## PLANNING REPORT

SEPTEMBER 17, 2009

#### 2. Metro Center PUD – Sign Plan 08-086AFDP

#### Metro Place North and South Amended Final Development Plan

# Proposed Sign Locations

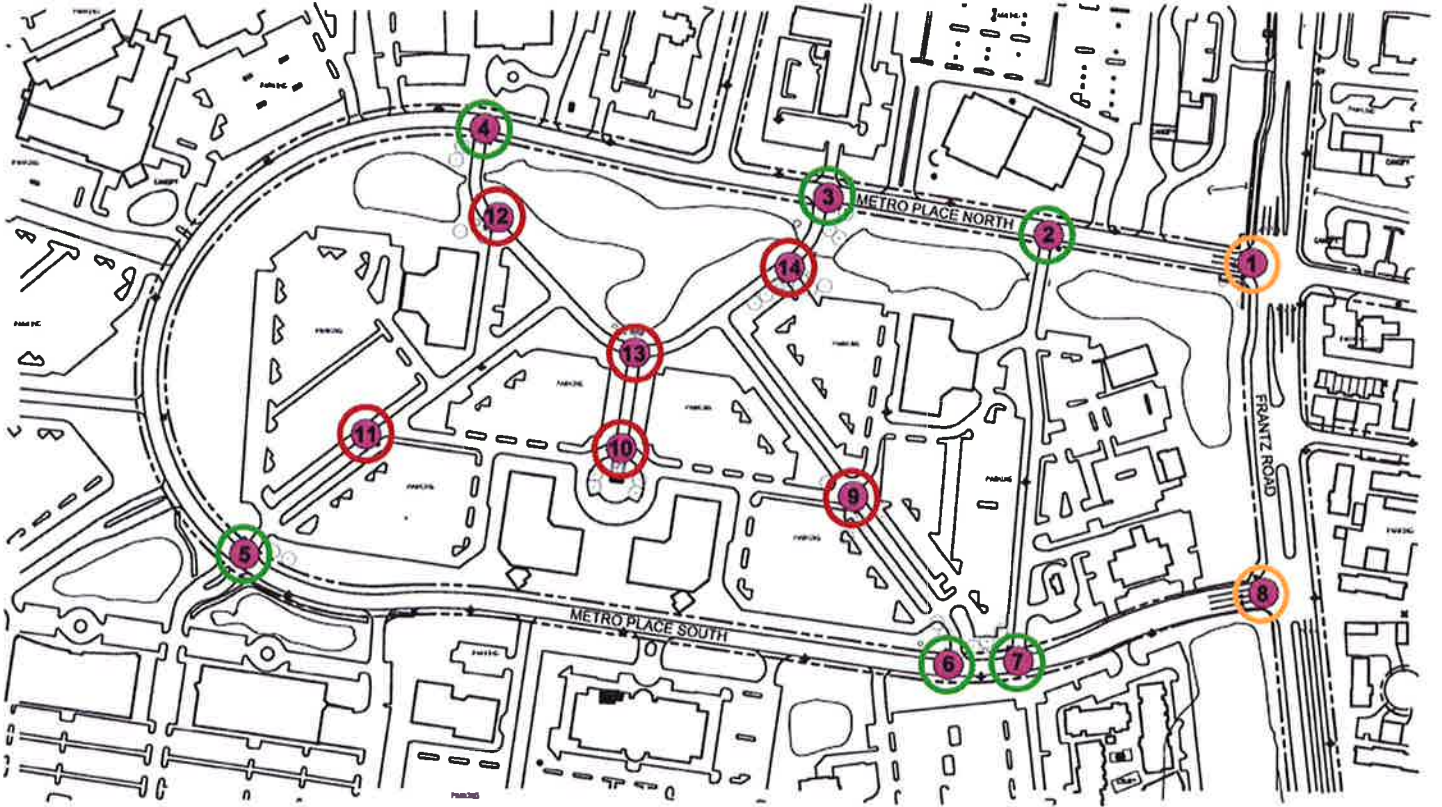
The plan indicates 14 new signs; two joint identification signs and 12 directional signs. Of the 14 signs, all but two are in the same location as the existing signs. All have a coordinated design scheme, with matching shape, color, font and overall design. Each sign is located within a landscape bed with no lighting proposed.

The joint identification signs (signs 1 and 8) are located at the Franz Road intersections with Metro Place North and Metro Place South. The 12 directional signs (signs 2-7 and 9-14) are located along Metro Place North and South and along the internal street.

The applicant is proposing 12 directional signs, 10 in the same location as the existing signs. The two relocated signs include Sign 5, in the southwest portion of the site that replaces a previously demolished sign, and a new Sign 7 to identify the addresses of the commercial businesses facing Frantz Road. The signs match the joint identification sign in design, color scheme and shape.

**Signs 1 & 8**

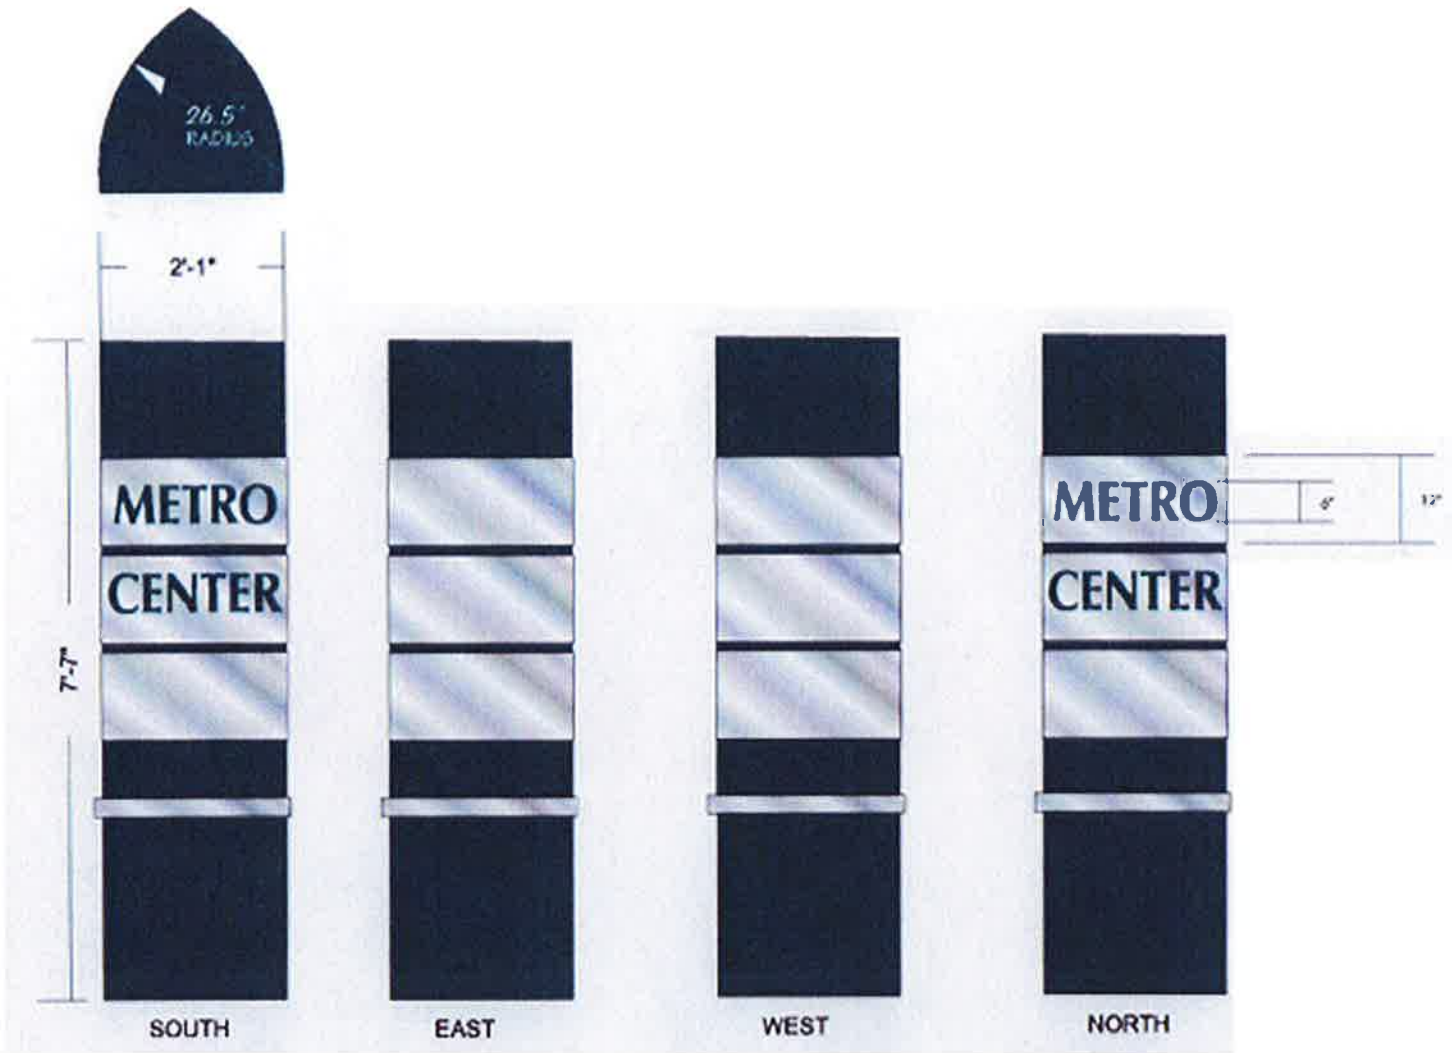
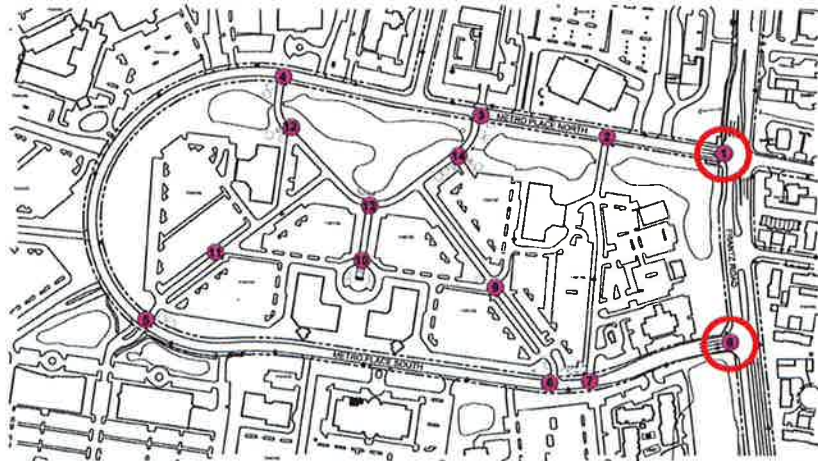
Metro Center currently includes two existing joint identification signs, Signs 1 and 8, along the Frantz Road intersections with Metro Place North and South. The applicant is proposing to replace the two existing 8-foot tall signs with two, 7 foot 7-inch signs, which meet Code. The two proposed signs will replace the existing signs located within the right-of-way. Signs in the right-of-way must be specifically authorized by the City Engineer and City Council. Following approval of this application by the Commission, the applicant will be required to receive a vote of approval from City Council for right-of-way encroachment request prior to sign permit issuance for signs 1 and 8. The sight visibility triangles for both signs indicate the signs do not impede visibility or safety.

The design of the proposed joint identification signs is a dark green background with satin silver horizontal bands and “Metro Center” located on the top two bands. The sign shape is rectangular, but the signs are three-sided with copy proposed for two of the three sides. Landscaping is proposed around the base of the signs to be consistent with other signs in the area.

Ms. Husak said the joint identification Signs 1 and 8 meet Code as far as height and content, but the issue is the location of the signs within the right-of-way. She requested the Commissioners comments. She said Council can grant a right-of-way encroachment, however the Commission would have to vote on the Amended Final Development Plan and allow them to be there first.

1. The applicant obtain approval from City Council for the right-of-way encroachment for Signs 1 and 8, prior to sign permit issuance.

**Signs 2, 3, 4, 5, 6, 7**

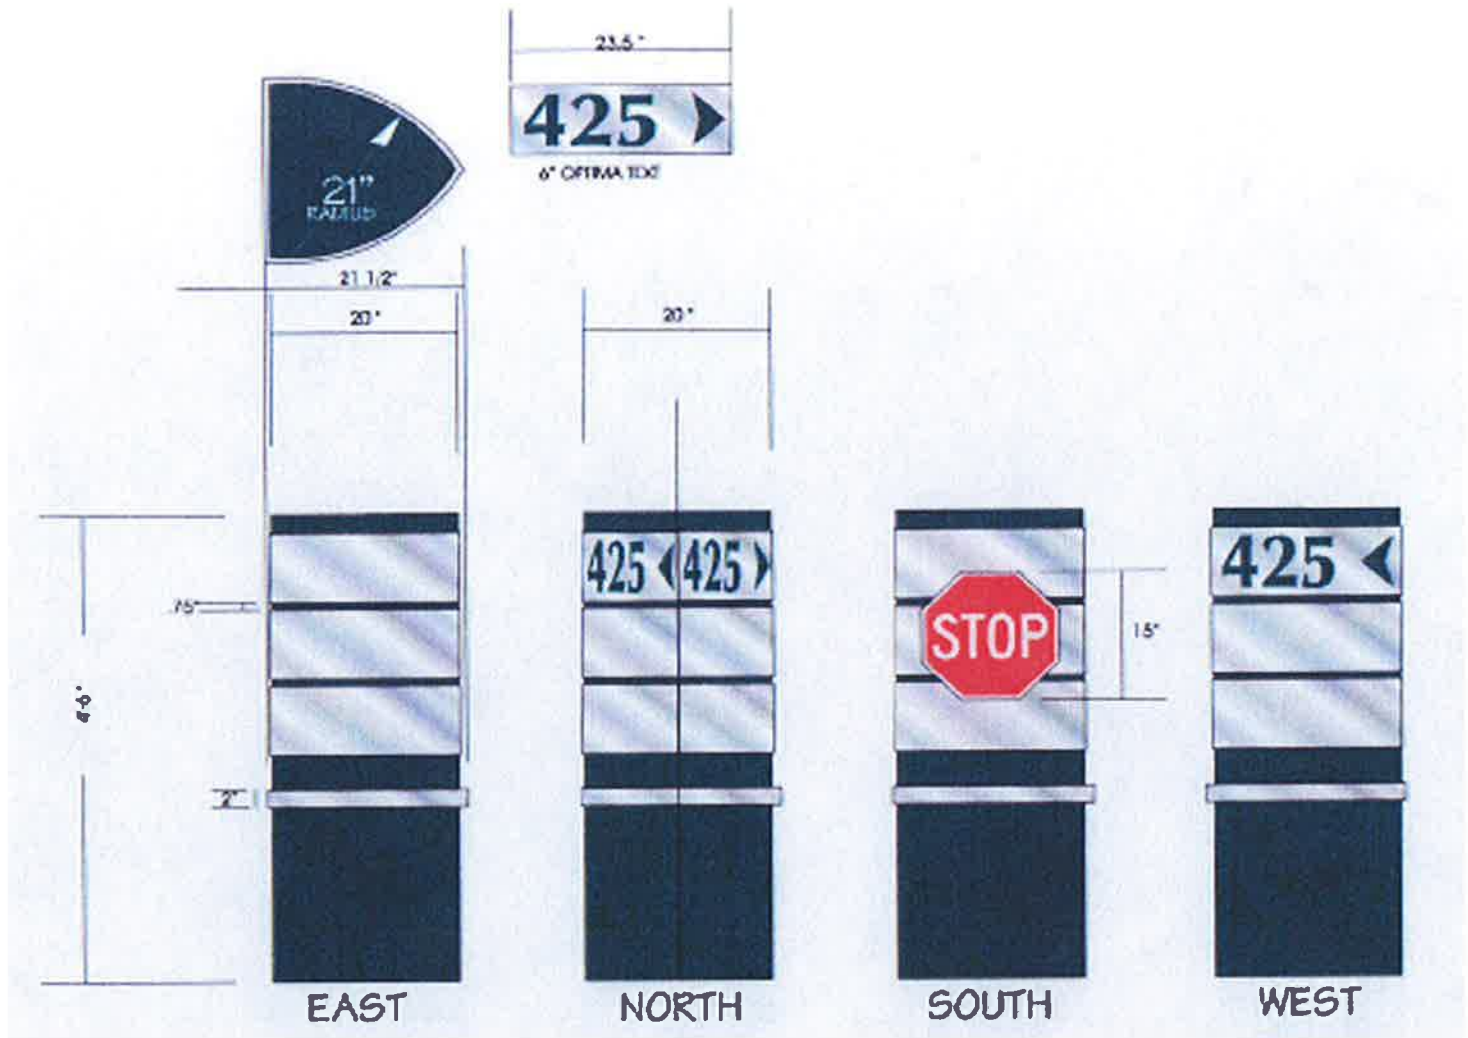
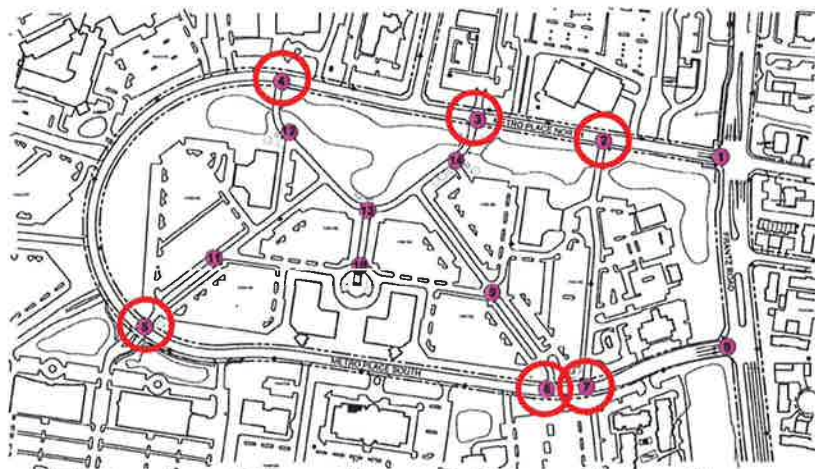
- *Signs 2-7.* The proposed 4 feet 6 inches tall signs are located at the private street entrances along Metro Place North and South, replacing the existing four-foot tall signs. The rears of these signs also serve as stop signs to regulate traffic from the internal private street to the public roads. These proposed signs exceed the height requirements for directional signs. While these signs are slightly taller than Signs 9-14, they provide much needed wayfinding into the Metro Center development and serve as identifiers for the various entrances, as they are located on the perimeter of the development.

**Criteria met with text modification.** The proposed sign plan meets Code, except as noted. The added six-inch sign height of Signs 2-7 is minimal and will aid in wayfinding. Following approval of this application by the Commission, the applicant will be required to receive a vote of approval from City Council for right-of-way encroachment request prior to applying for a sign permit for Signs 1 and 8 (Condition 1).

Code Section 153.053(E)(2)(b)(4)(B) permits the Commission to approve deviations from the development text and Zoning Code. The modification requested is to increase the height requirement for the directional signs for Signs 2-7.

While this proposal fails to comply with the amended final development plan criteria set forth in Section 153.055(B) of the Dublin Zoning Code because of the increased height of the signs, unless otherwise approved by the Commission. Planning supports the increased height due to aid in wayfinding for the development and recommends approval of the modification to the development text.

**Signs 9, 10, 11, 12, 13, 14**

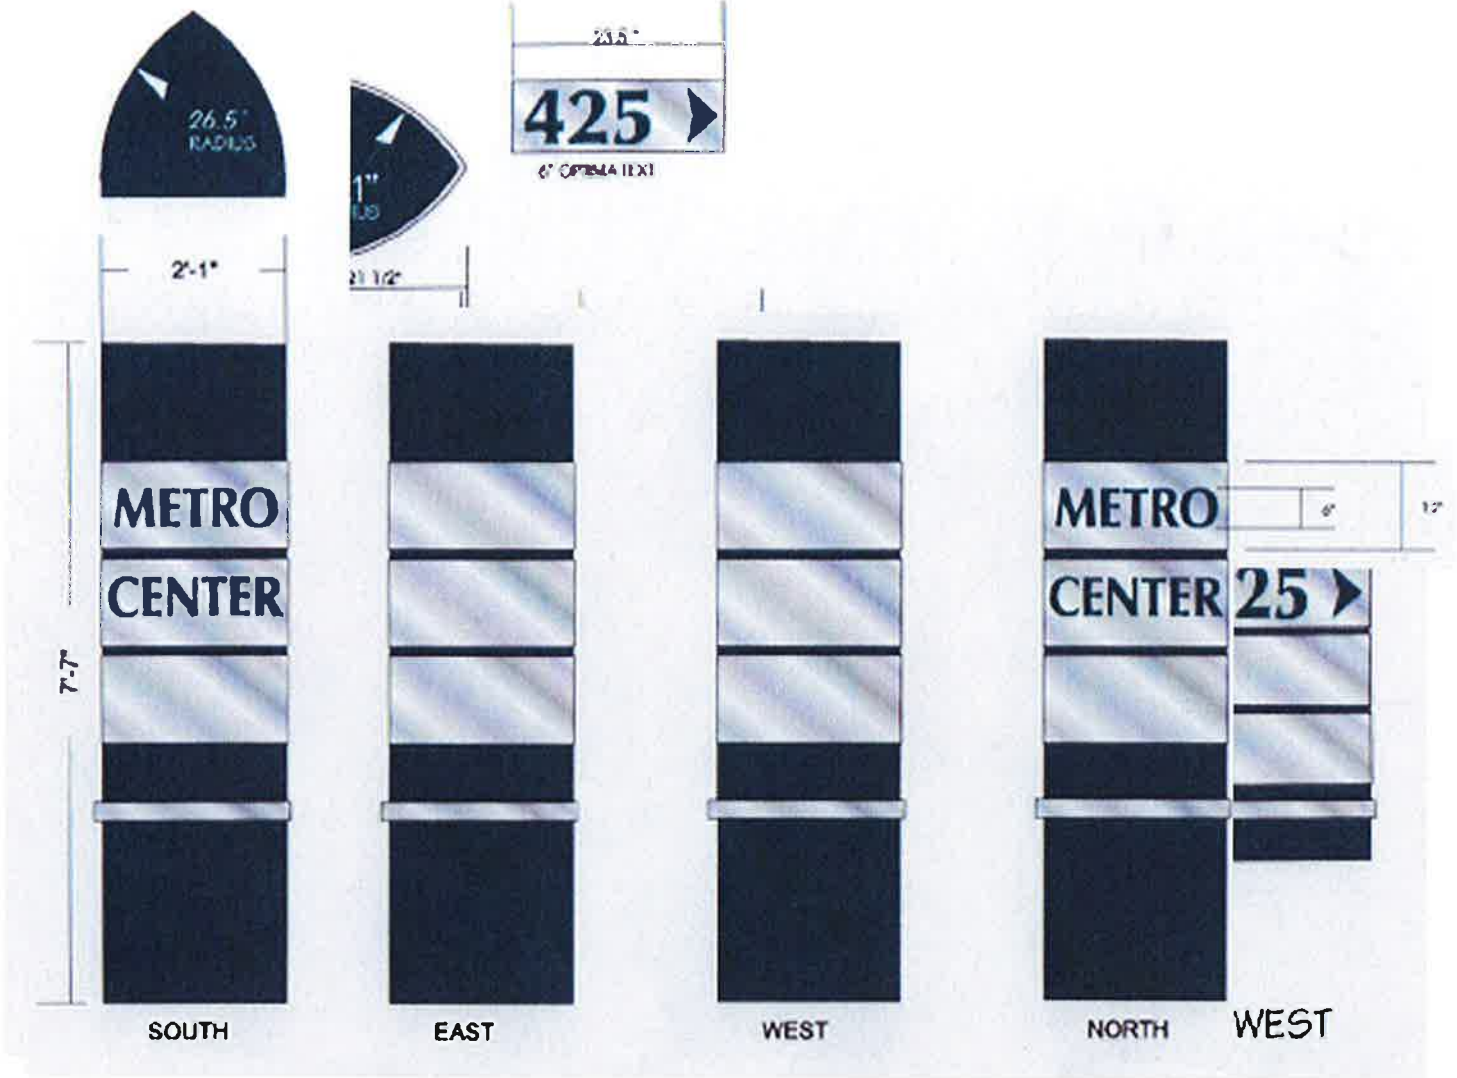
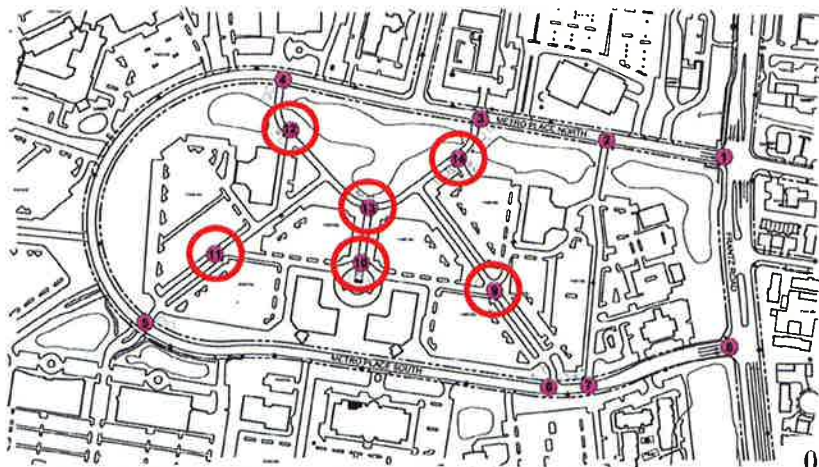
- *Signs 9-14.* The proposed 3-foot tall signs are located at along the private streets, internal to the development, replacing the existing four-foot tall signs. The rears of these signs also serve as stop signs to regulate traffic from the internal street to the public roads. The proposed signs, which meet Code are smaller than Signs 2-7, as they are located interior to the development and serve to direct patrons to a specific building.
